**Application for Planning Permission for
Proposed House at Tuen Mun Town Lot No. 550 (TMTL 550), Tuen Mun, N.T.
(Application No. A/TM/601)**

Table 1: Responses to Comments from Government Departments on Planning Application No. A/TM/601 (13 November, 2025)

Revised Drainage Impact Assessment

SCALE	AS SHOWN	DATE	November 2025
CHECKED	ELK	DRAWN	TEAM
FIGURE NO.	Figure 1.2		REV
			-

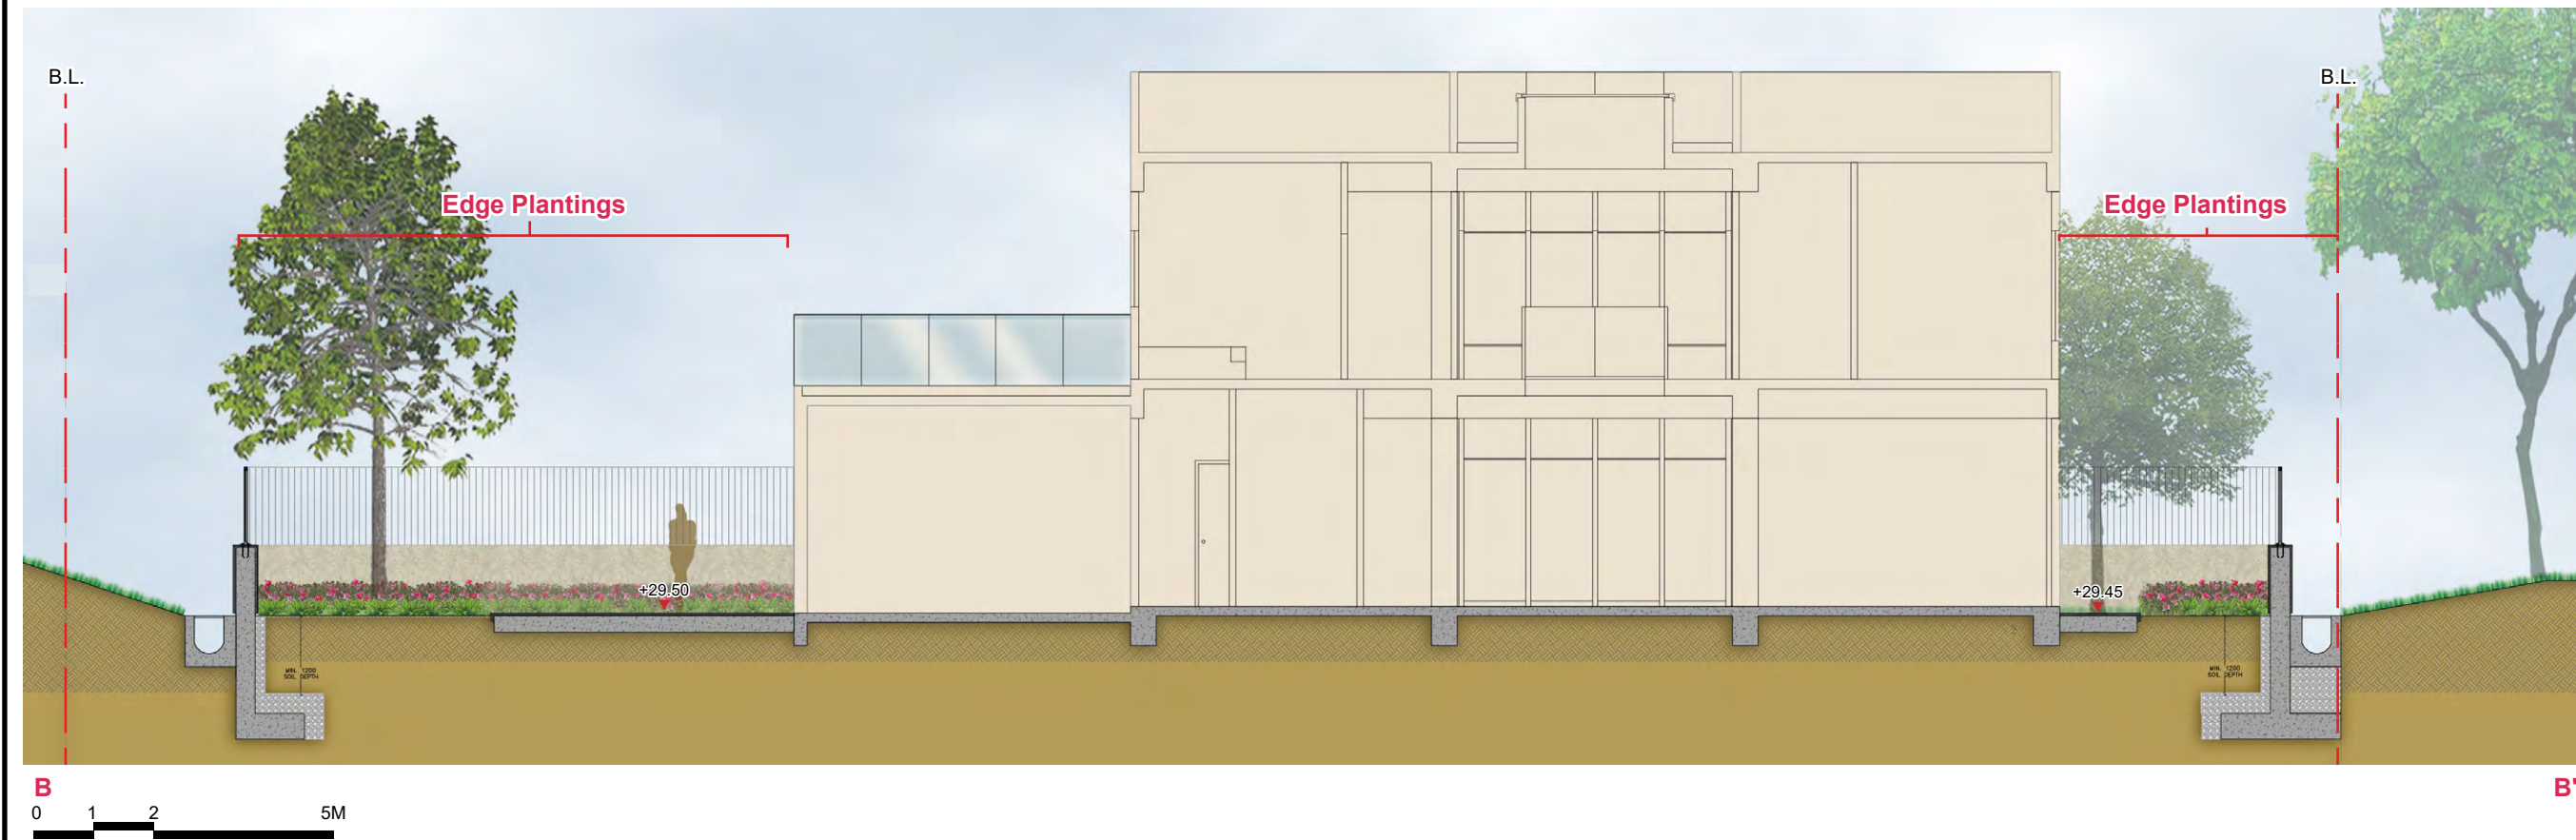
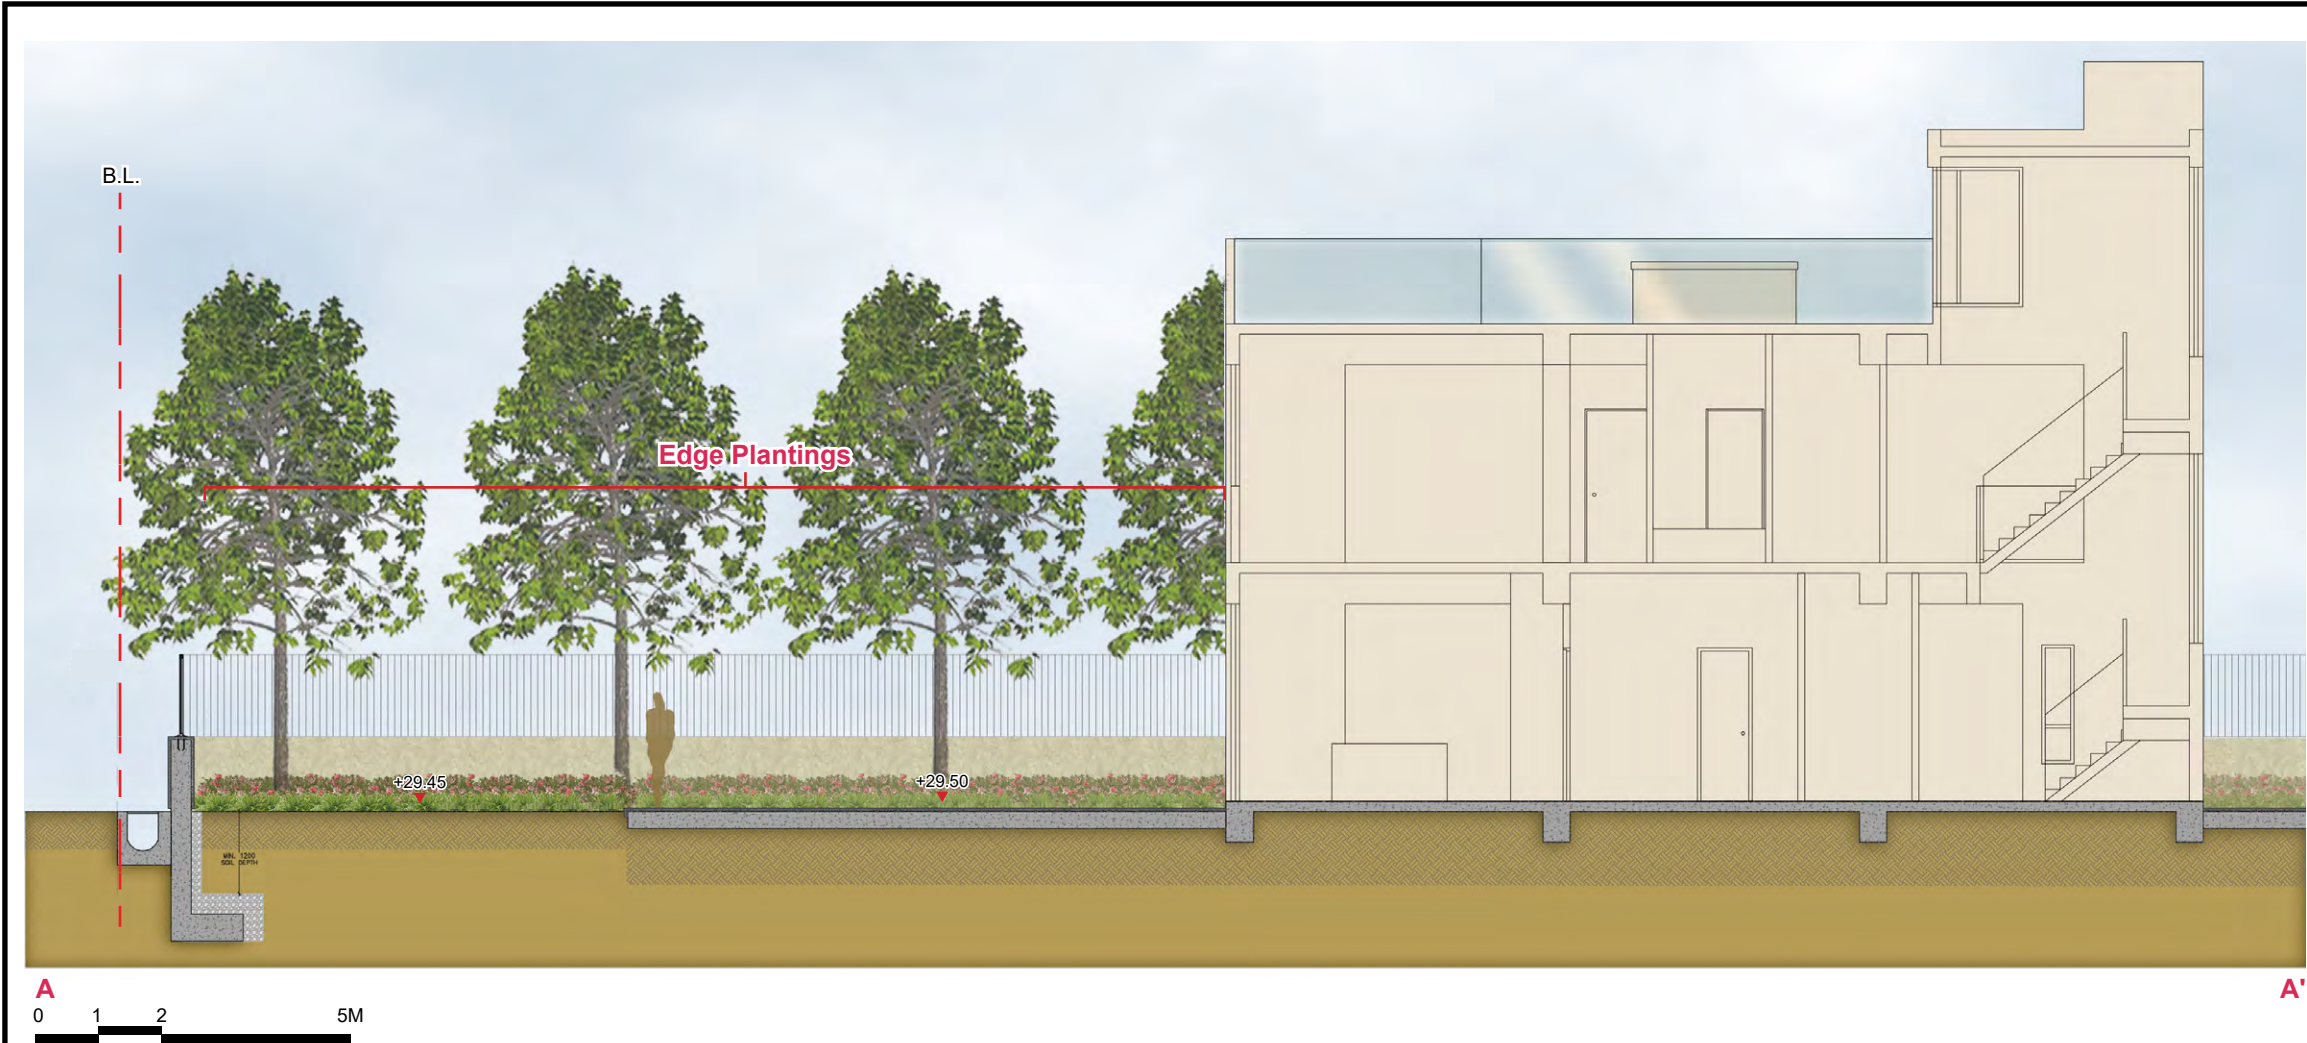
c. <u>Figure 1.1 & 1.2 (Landscape Plan)</u> i. It is observed that some grey and beige colors occupy a large portion of the application site that is connected to the pedestrian and vehicular entrance/exist, but they are not indicated in the legend table. Please review.	i. Relevant legend added (see Annex E).
ii. A discrepancy in the proposed soft-landscape treatment is observed among this figure, Section B-B', and paragraph 9.10. Paragraph 9.10 notes "<i>Hydroseeding on sloping area</i>." However, the Landscape Plan shows that the northern area adjacent to the application boundary is proposed for lawn planting, while Section B-B' indicates that the proposed lawn area is a slope. Please review.	ii. "<i>Hydroseeding on sloping area</i>." is a potential treatment on slope/retaining wall. Whilst there is no sloping area proposed within the application site, this sentence in para. 9.10 has been deleted. Section B-B' is cutting across the site showing the edge plantings, part tree planting in lawn in the north of the site can only be seen in far and largely screened by the house. These planting behind the house is added to Section B-B'. Existing sloping green is location outside the application site. Relevant text and figures of Landscape Proposal and Tree Survey Report have been revised (see Annex E).
